Rezoning Application: PD 25-0261**Zoning Hearing Master Date:** April 15, 2025**BOCC LUM Public Hearing Date:** June 10, 2025**Hillsborough
County Florida**

1.0 APPLICATION SUMMARY**Applicant:** Sheldon OMV, LLC**FLU Category:** SMU-6**Service Area:** Urban**Site Acreage:** 0.81 acres**Community
Plan Area:** Riverview**Overlay:** None**Introduction Summary:**

AGENCY REVIEW COMMENT SHEET

PETITION NO: RZ 25-0261-
REVISED

2.4 Proposed Site Plan (partial provided below for size and orientation purposes. See Section 8.0 for full site plan)

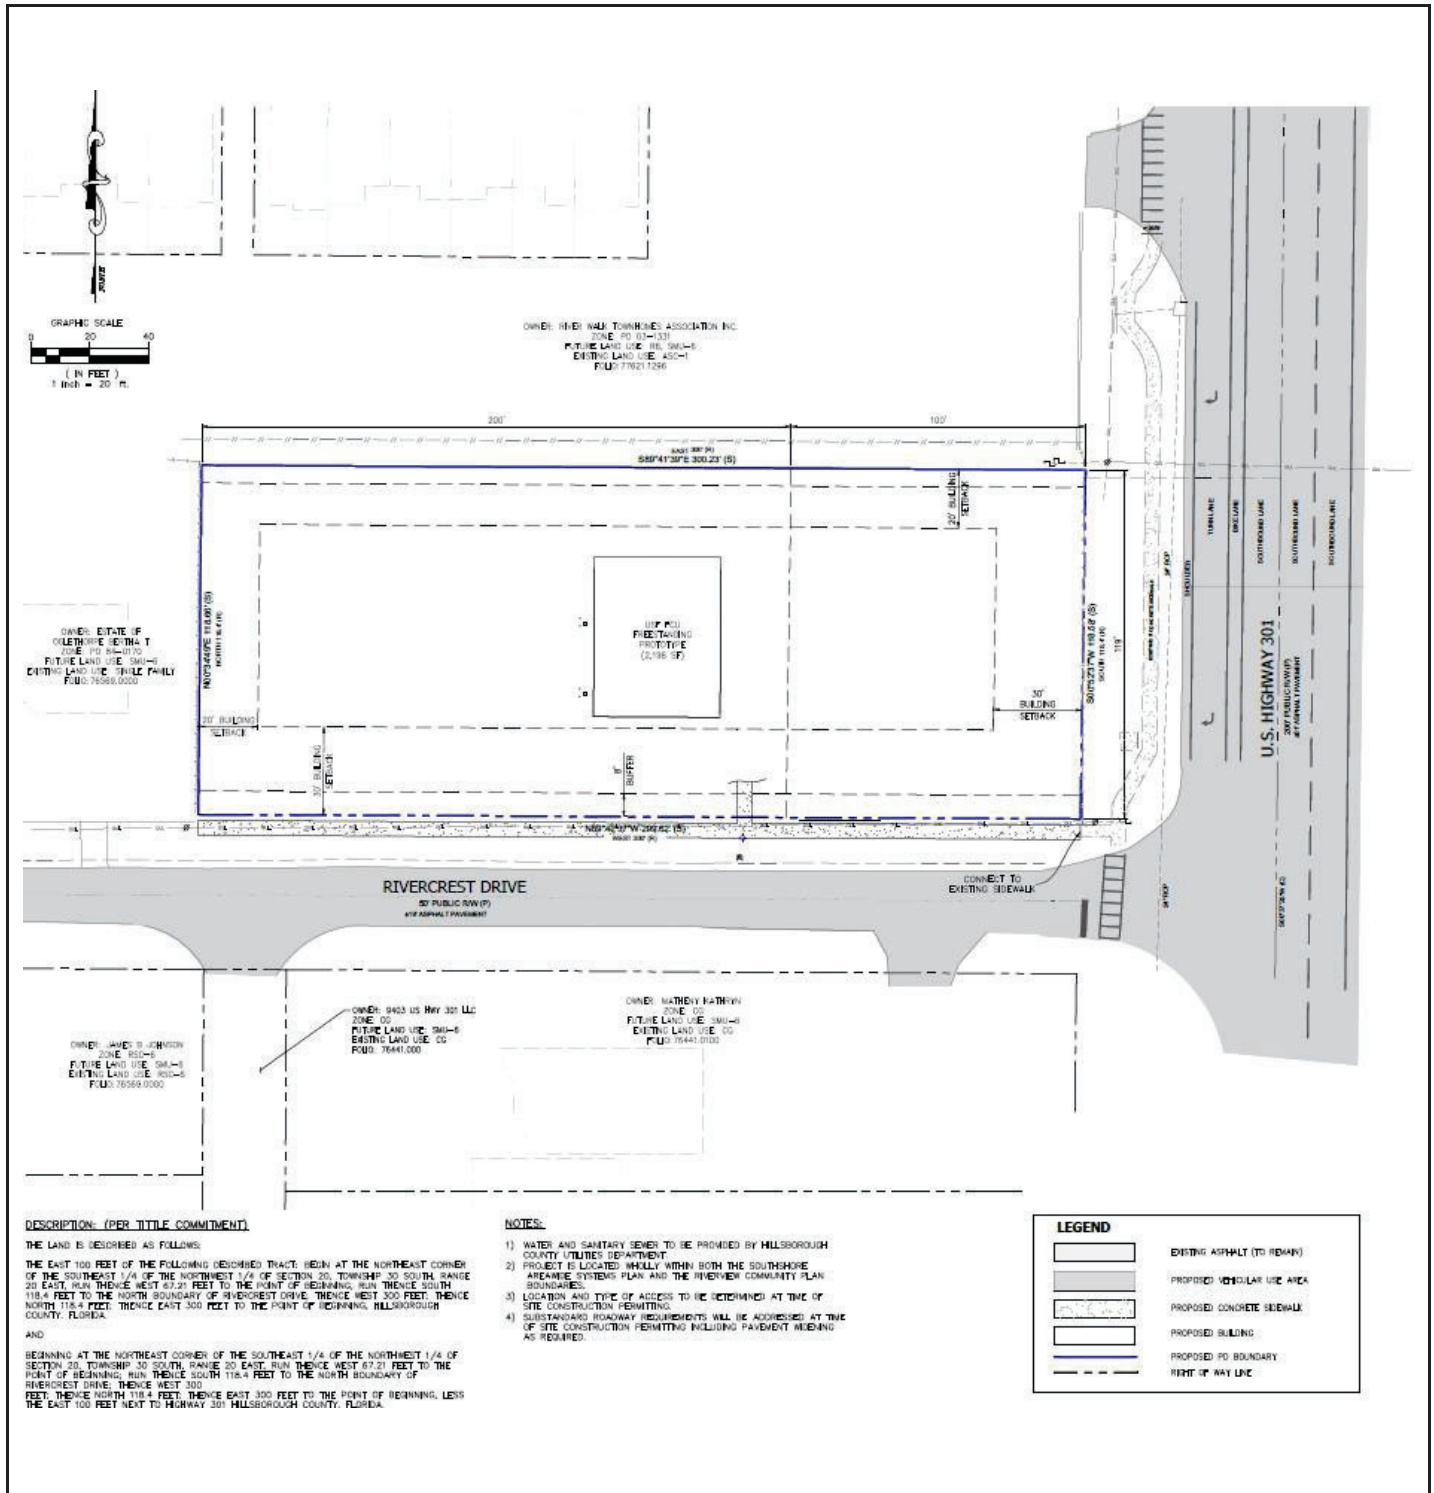
Approval– Approval of the request, subject to the conditions listed below, is based on the general site plan submitted April 3, 2025.

- 1. Development shall be limited to a Bank/Credit Union with drive through facilities. The use shall be developed where generally shown on the site plan.
- 2. Development shall be in accordance with the following:

- 7. If the notes and/or graphic on the site plan conflict with specific zoning conditions and/or the Land Development Code (LDC) regulations, the more restrictive regulation shall apply, unless specifically conditioned otherwise. References to development standards of the LDC in the above stated conditions shall be interpreted as the regulations in effect at the time of preliminary site plan/plat approval.

9. Notwithstanding anything shown on the PD site plan to the contrary, the presence or absence of access, number, design and location of the access point(s), including roadway stub outs and/or vehicular cross access shall be regulated by the Hillsborough County Land Development Code, Transportation Technical Manual (TTM) and other applicable regulations. The design, relocation, modification, closure or addition of median openings and curb cuts are subject to approval by Hillsborough County Development Services at the time of plat/site/construction plan approval. The need for site access improvements at project entrances and affected intersections will be determined at the time of plat/site/construction plan approval, and access location or characteristics may require Sec. 6.04.02.B. Administrative Variances and/or Design Exceptions which will be adjudicated at the time of plat/site/construction plan approval. Applicants who are unable to meet access management regulations, other applicable regulations, and/or obtain the appropriate relief may be unable to construct the project to its maximum entitlements.

11. The developer shall construct a 5-foot-wide sidewalk along the project's frontage consistent with Section 6.03.02 of the Land Development Code.
12. Notwithstanding anything herein or shown on the PD site plan in the contrary, bicycle and pedestrian access may be permitted anywhere along the PD boundaries.

13. Notwithstanding anything shown in the PD site plan or therein the conditions of approval, the applicant shall provide internal sidewalks connections to the project site arrival point, the primary building entrances, parking, and any other onsite amenities consistent with 6.03.02 of the Land Development Code.
